## Firmware 2.06.3 bug list:

## List of bugs/improvement requests

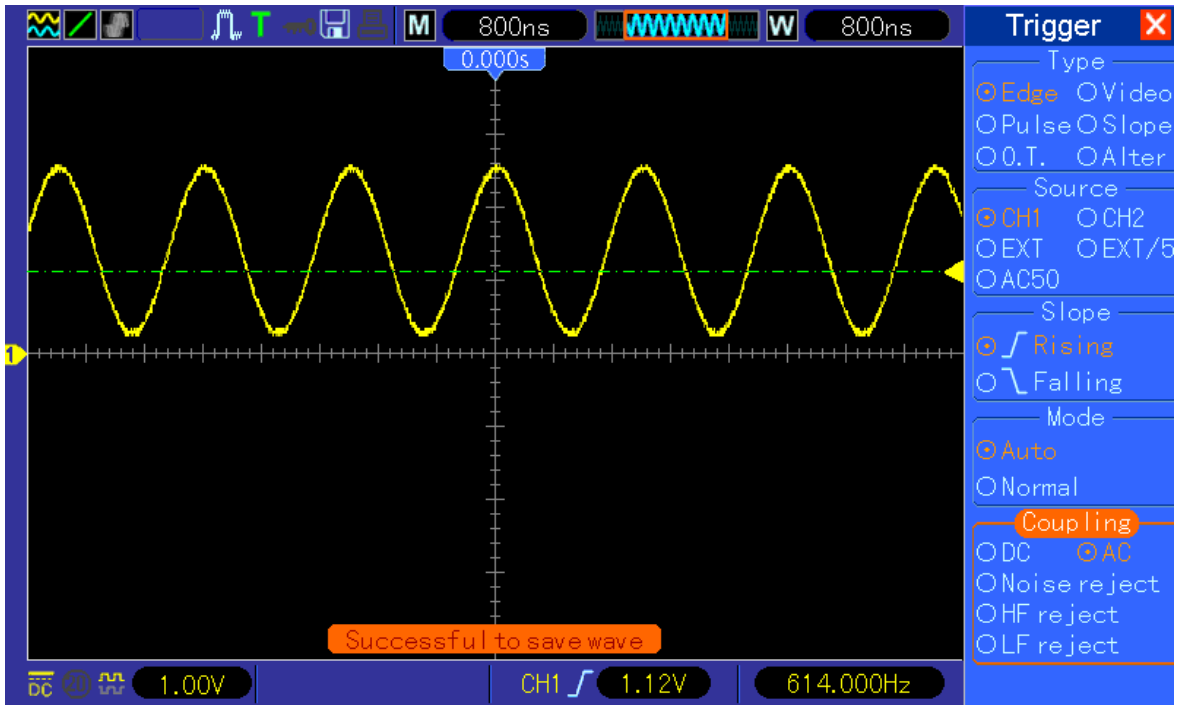
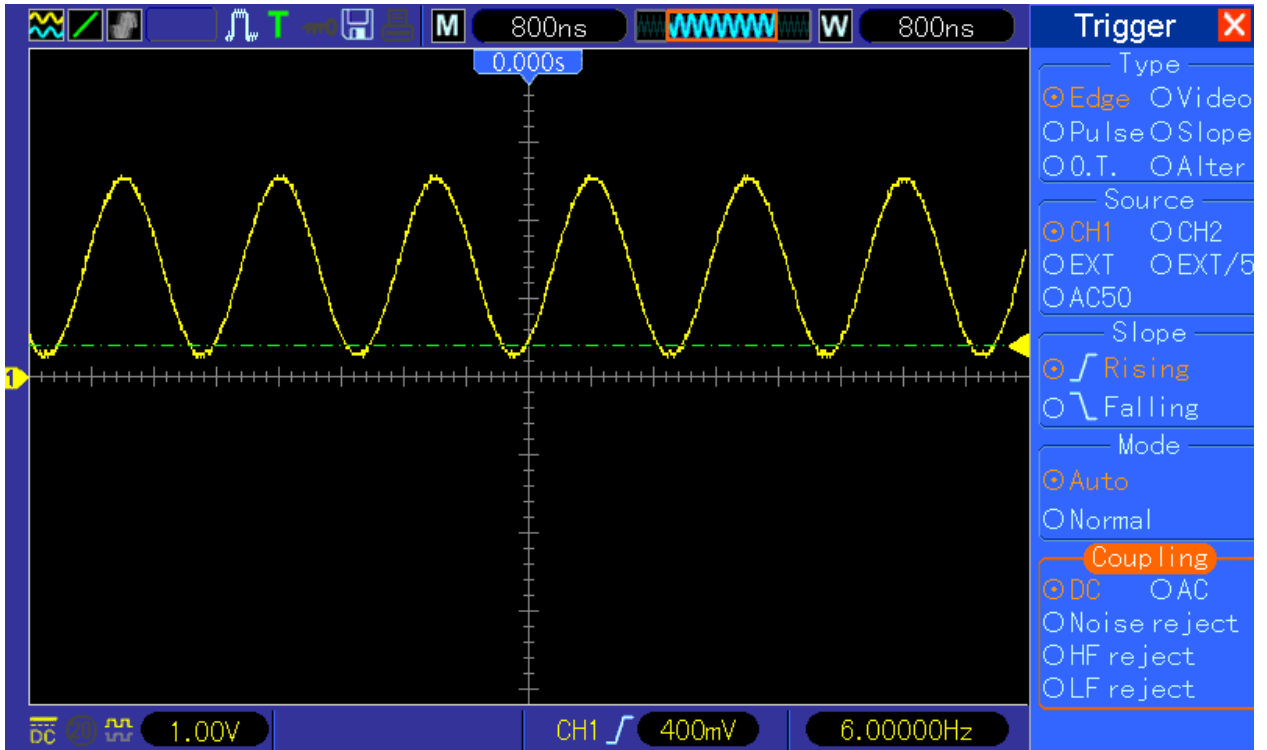
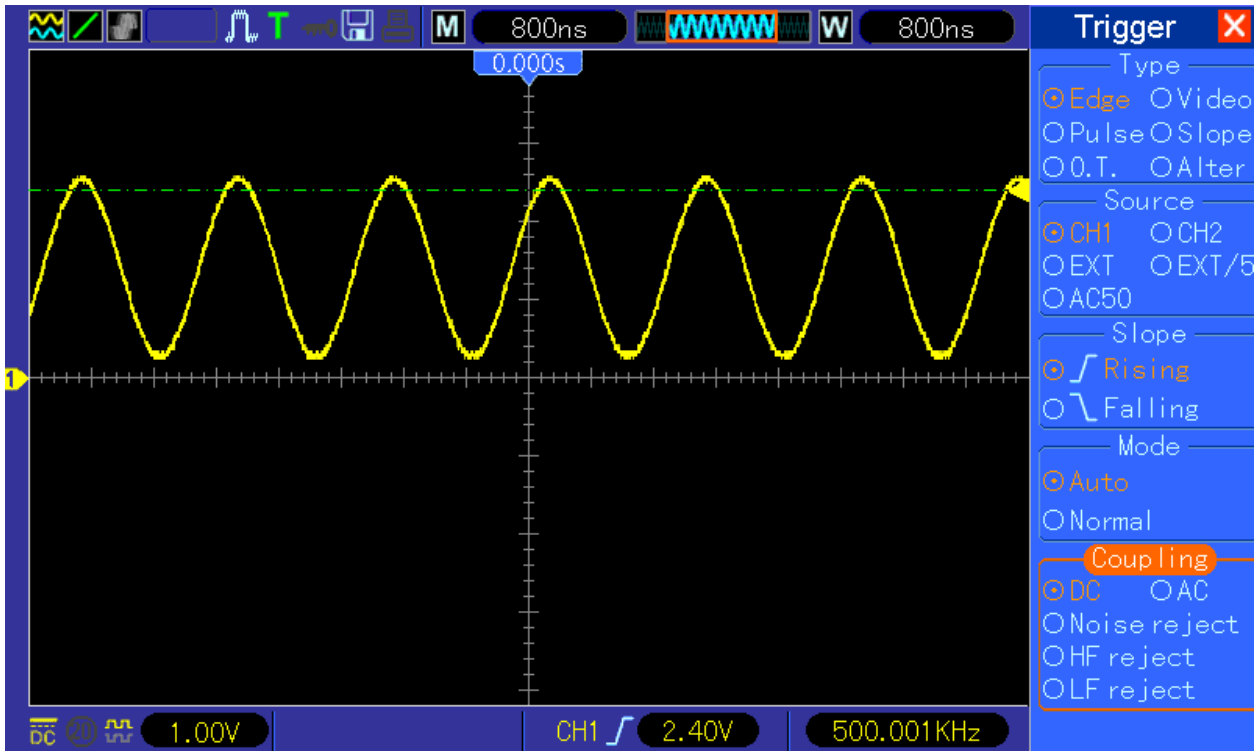
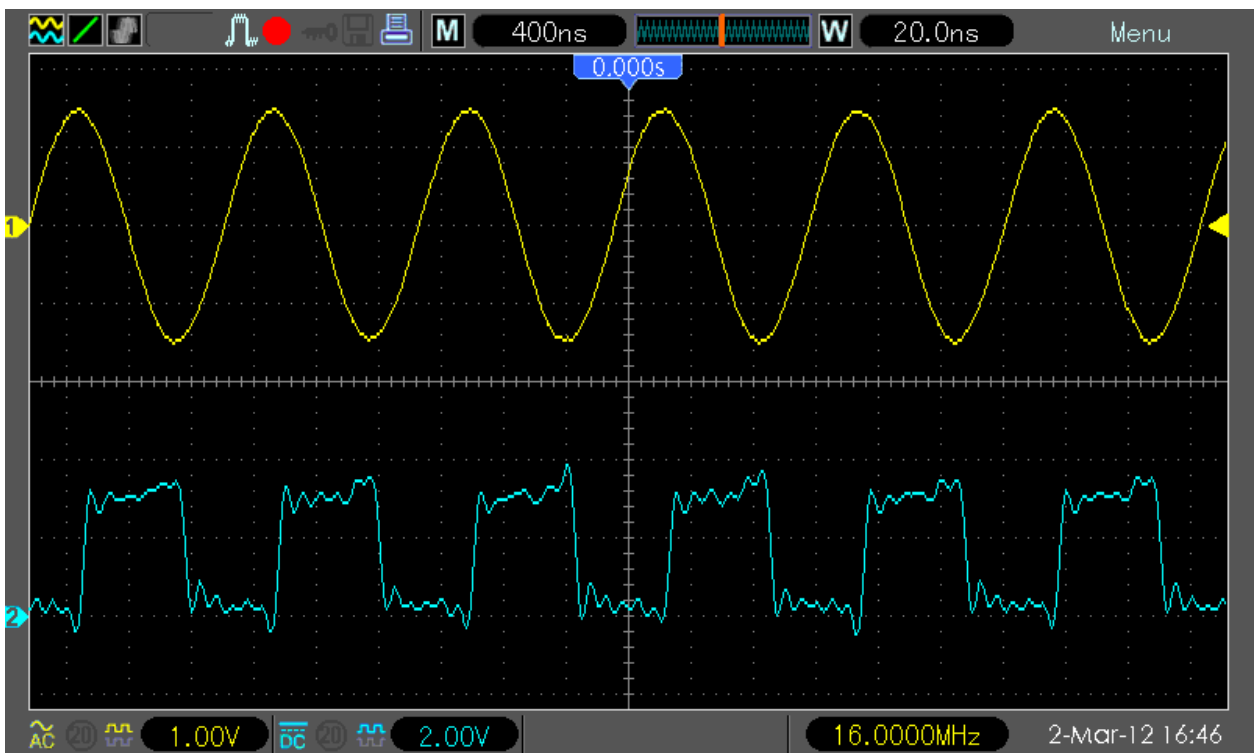
13. AC trigger indicator and line wrong. Set ch1, signal DC coupled, trigger AC coupled. The trigger lowest level below signal :

highest level only mid of signal

But both should look like when trigger coupled in DC mode:

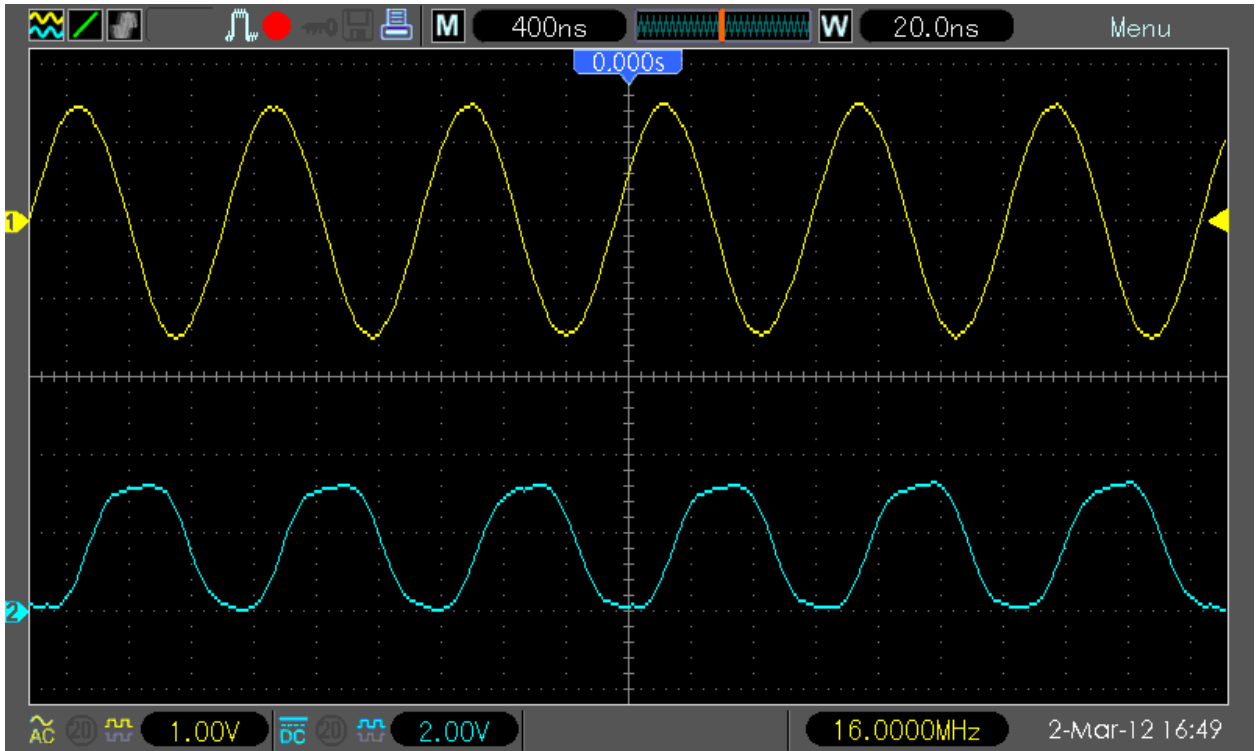
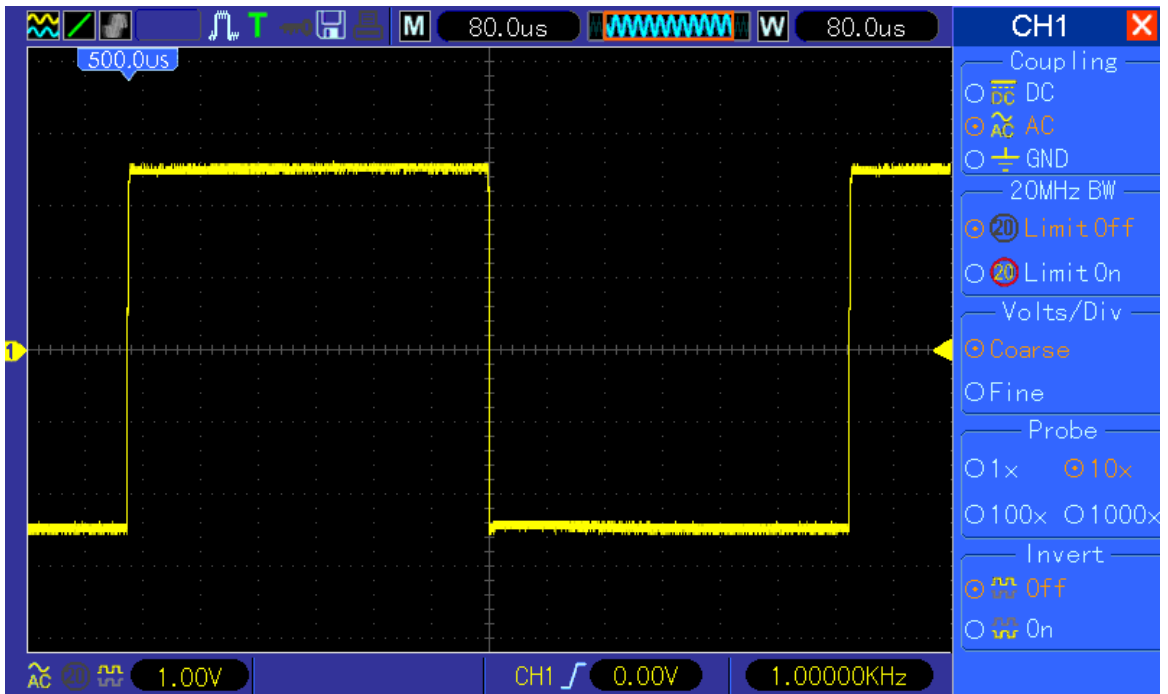
14. Dithering/interpolation filter of waveform too sharp. When enabling both channels (this also occurs in single channel mode and 1GSs, but test signal need to be higher to get same error) and applying for example 16MHz square wave the waveform is switching between proper square:

and crippled square every second:

14. For sure a stupid bug, but since you can see when the signal is “wobbling” you can quick change (when necessary) to single channel to observe the waveform with better resolution and without wobble.
15. Funny bug, but easy to omit since we know it (remember, with higher sample depth there is no issues)
16. This is already fixed, the /dsod (or /dso/app/dsod — this depends on fw/DSO model version) binary is working perfectly as watch dog monitoring potential profile issues.

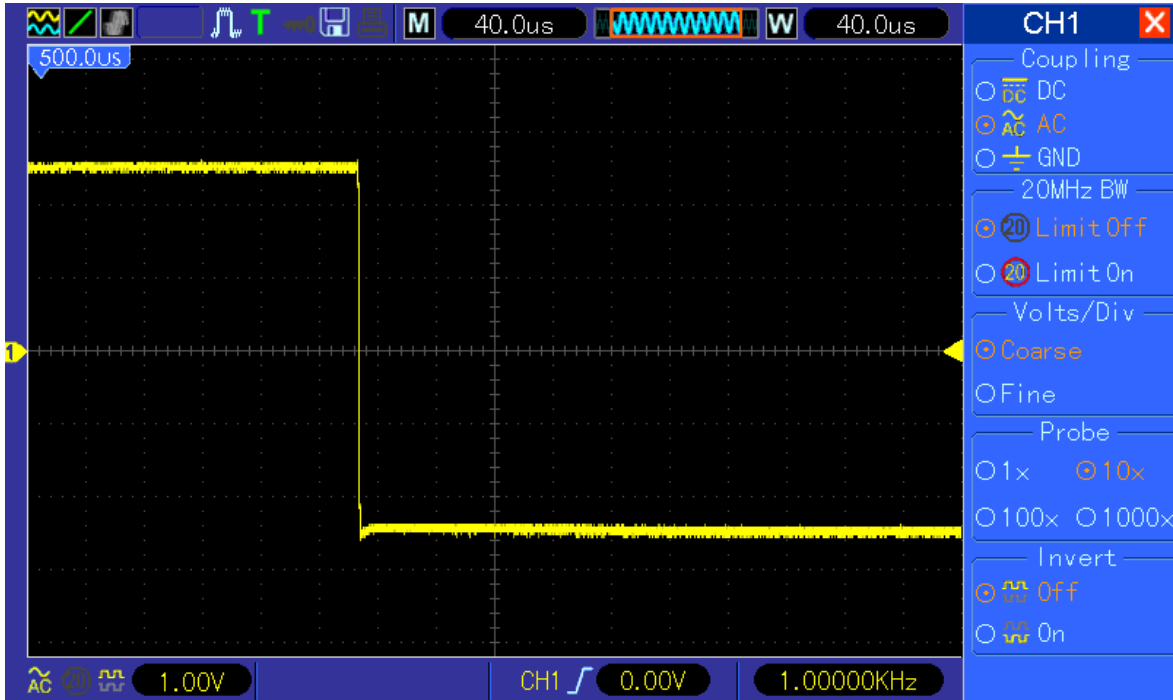
15. Display / Time base scaling strange behavior. When you apply e.g. 1kHz signal, set time base to 80us/DIV and move the waveform to 500us/DIV (bug only in 4/40k memory depth, 512k/1M/2M works fine):

When you now change time base to 40uS/DIV the falling edge (which should be still in the middle of the screen) has been moved to 454uS position (but it should stay on 500uS). The same happens of course with 20uS/DIV.
